Pretty Composite Textiles Ltd (extension of S.Suhi Industrial Park Ltd) Oxford Colours Ltd.

26 June 2022

Buildings Information

Observations

Foundation Layout Plan

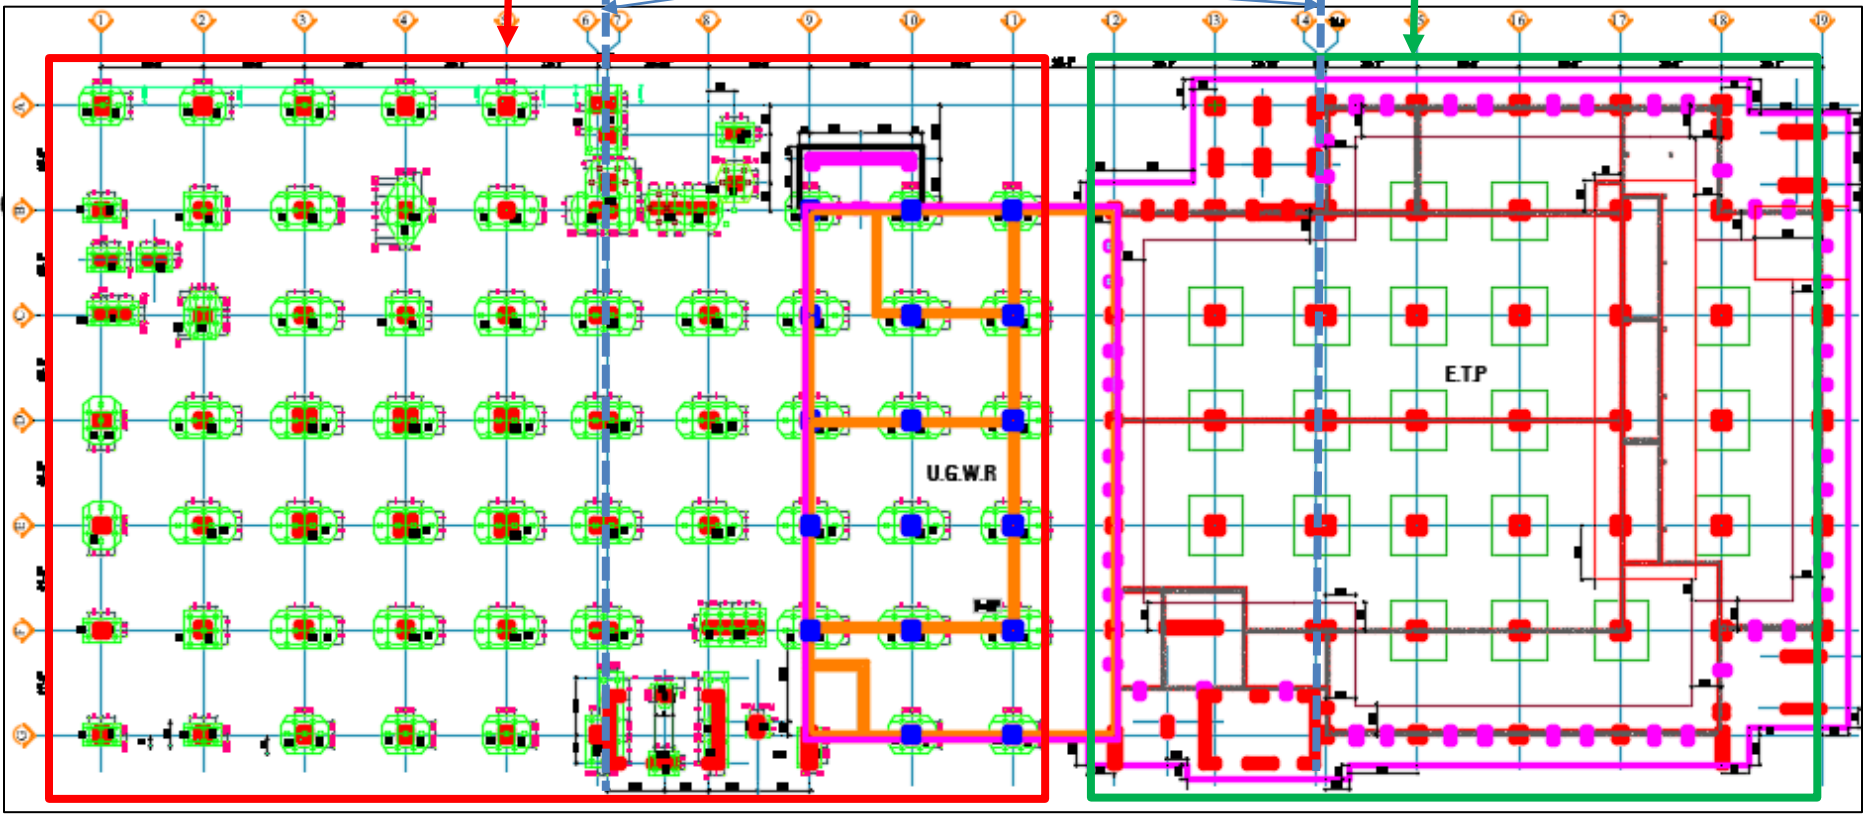
Settlement check for different foundation system

Shallow and Deep foundations are constructed and connected with the beams. Building engineer is required to check the differential settlement issue for the deep and shallow foundation.

Live load plan- 3rd floor (live load considered as 4 kPa and no occupancy type is mentioned)

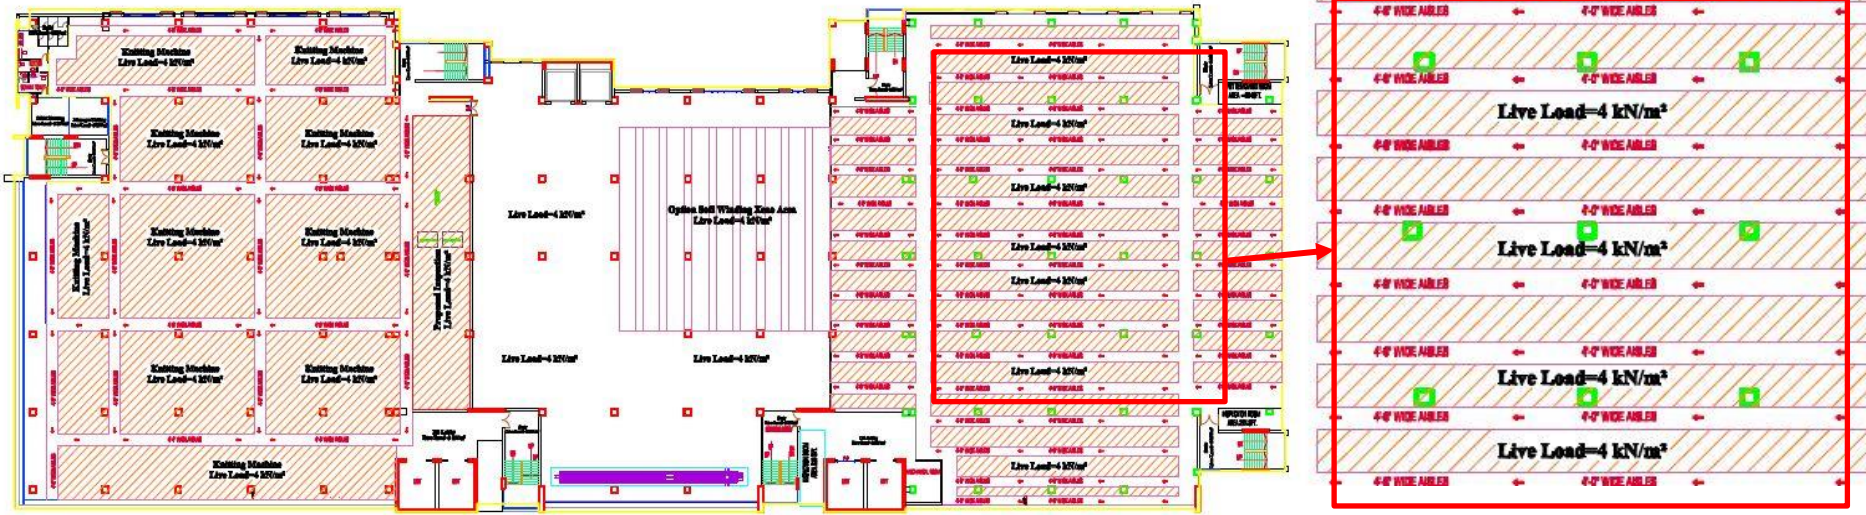
Live load consideration at storage areas

Live load on 3rd floor is considered as 4 kPa in prepared load plan (occupancy type not mentioned). Storage was found on 3rd floor. As per BNBC live load for light storage areas is required to be considered minimum 6 kPa. However, the factory engineer is required to revise the load plan as per BNBC requirement and review the design accordingly.

Building is designed as 8 storied

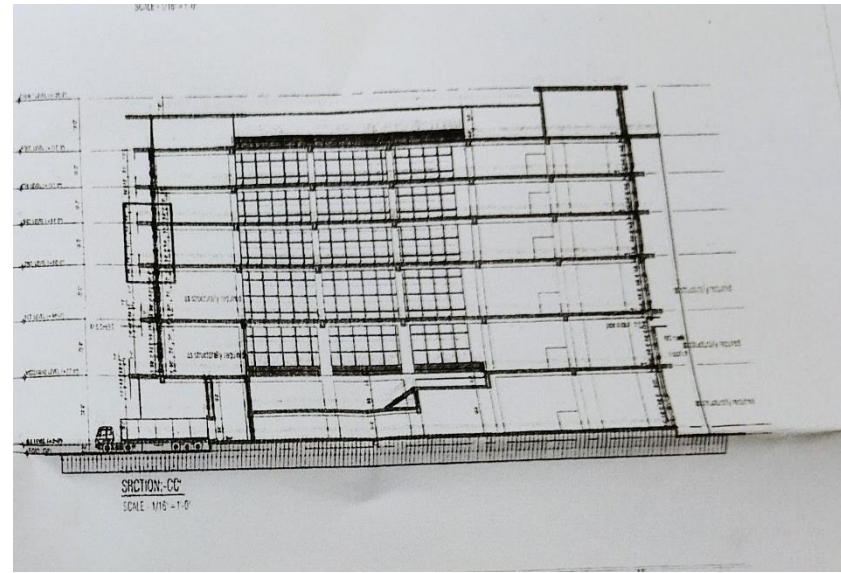
The building has permit drawing for 6 storied and factory is conducting vertical extension.

COLUMN LAY-OUT PLAN (BELOW GL)

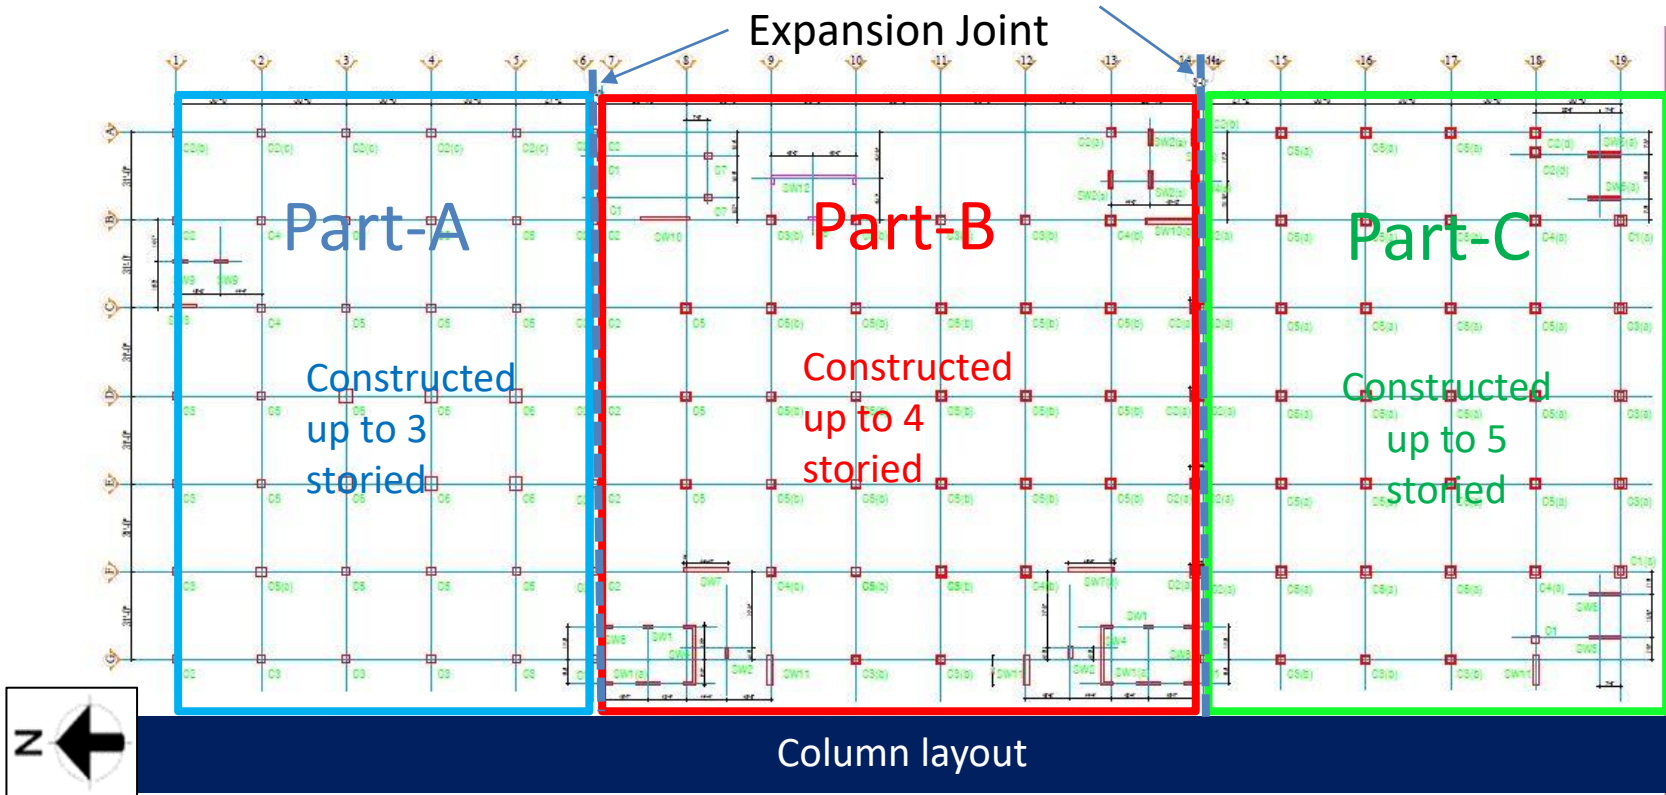
Ongoing vertical extension work

The building has permit drawing for 6 storied and factory is conducting vertical extension at all tree parts. Factory is required to seek approval from local authority before conducting extension above 6 storied. Also, a Detail Engineer Assessment (DEA) is required to completed before the construction above 6-storied.
